DEFENSE NUCLEAR FACILITIES SAFETY BOARD

Staff Issue Report

SUBJECT: Review of Building 3019 Ventilation Systems Required for Safe Uranium-233 Operations and Long-Term Storage

RDF VENTILATION SYSTEMS

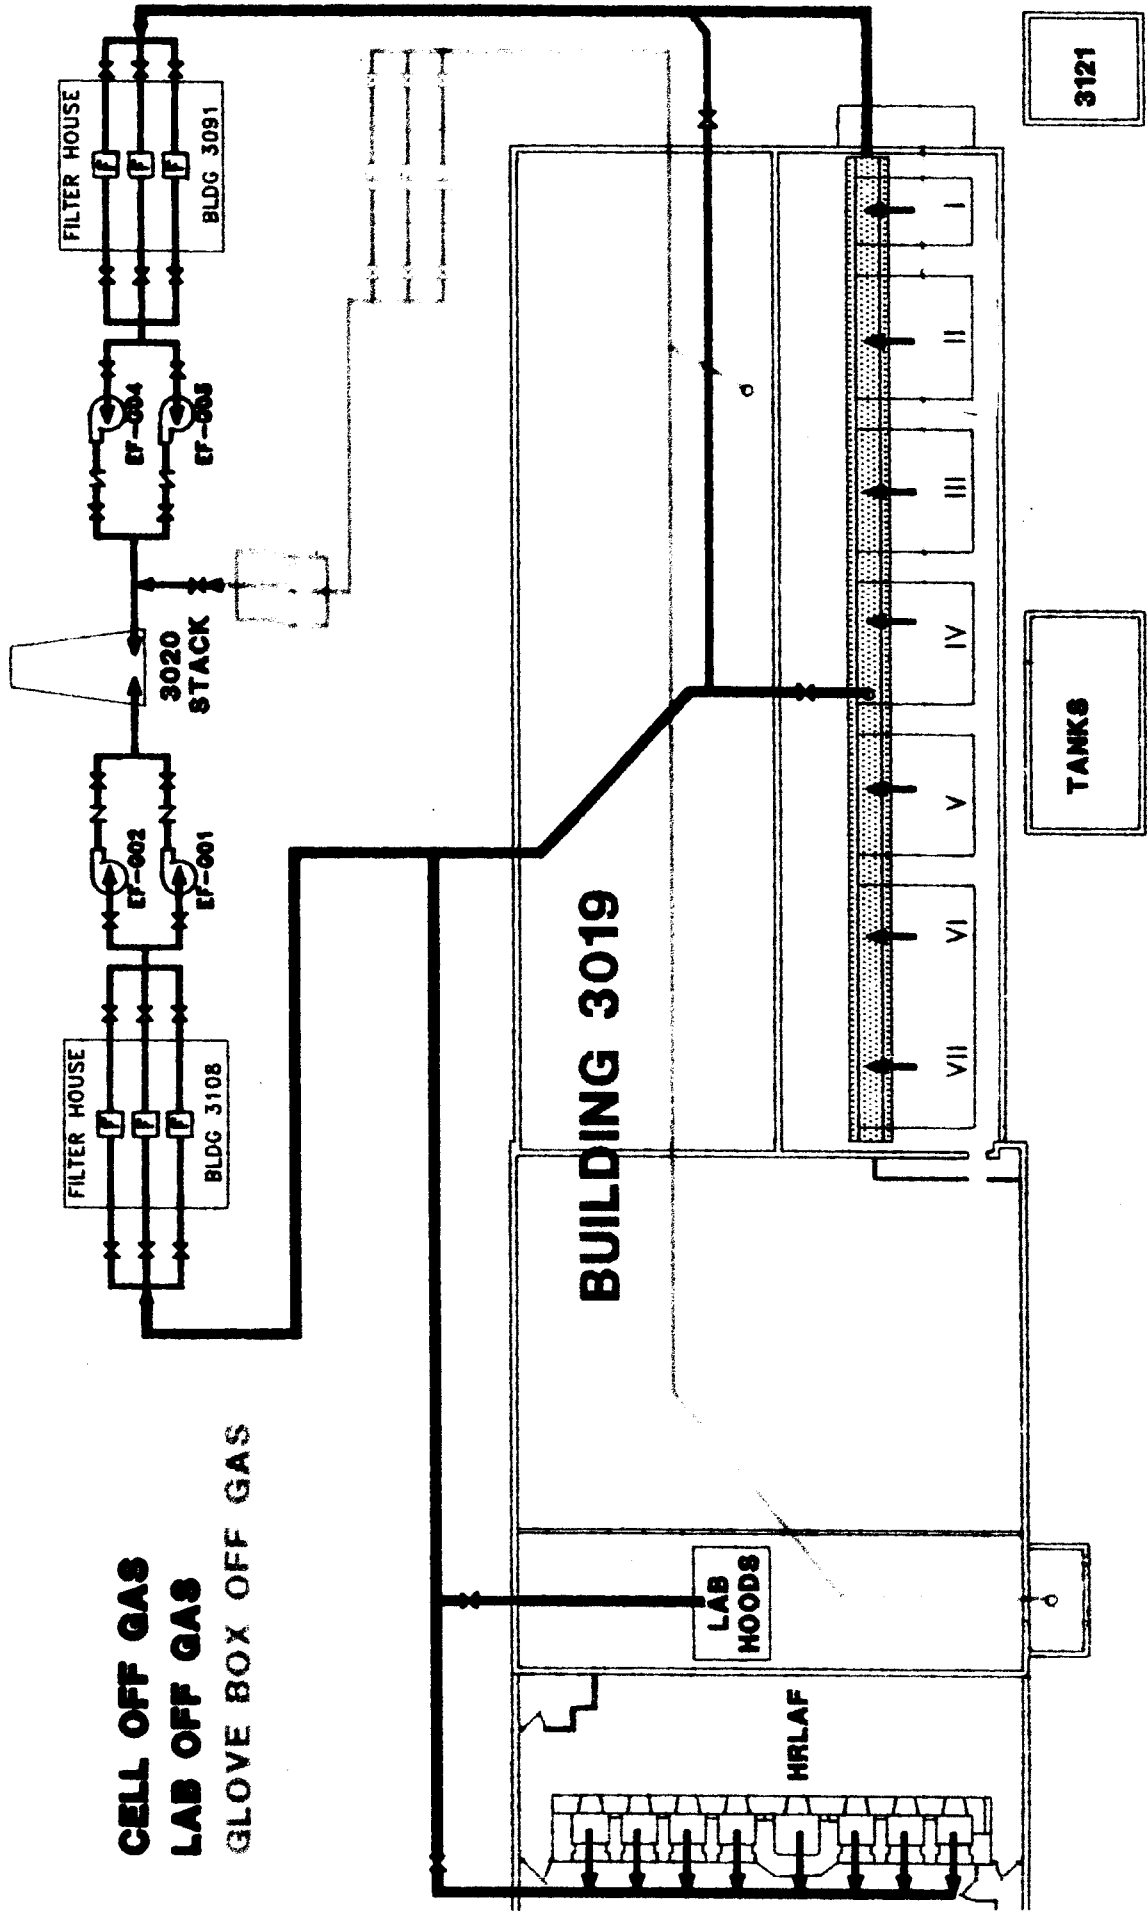
Discussion. Four off-gas systems ventilate Building 3019 (see attached diagram): (1) the Laboratory Off-Gas system (LOG), (2) the Cell Off-Gas system (COG), (3) the Glove Box Off-Gas system, and (4) the Vessel Off-Gas system (VOG). Most of these systems normally exhaust to the 3020 stack, the principal release point for the building. The primary ventilation system serving the uranium-233 inspection and storage areas is the VOG. Unlike the other

Building 3019 ventilation systems, the VOG usually exhausts through stack 3039. The VOG cross-connects to the COG and can therefore exhaust to either the 3020 or the 3039 stack. Further complicating the situation, the LOG can also be aligned to the COG.

The VOG system provides containment for any contamination released from the storage vaults. During certain operations involving movement of containers from the vaults, it is possible for a breached container to contaminate considerable lengths of the VOG ductwork because no filtration is provided near the point of potential release. The VOG exhausts through a filter at the 3039 stack, which is located approximately 100 yards away down a hill from Building 3019. Portions of the outside VOG lines are unshielded, and operations at the 3039 stack are under the purview of the waste management contractor. This situation can represent a potential hazard to nearby workers.

Finally, the lack of filtration close to the source of potential contamination releases in the VOG system may pose an unreviewed worker exposure issue. The staff believes selected compensatory measures (e.g., prefilters in the inspection chamber) are necessary for the VOG system prior to initiation of uranium-233 operations.
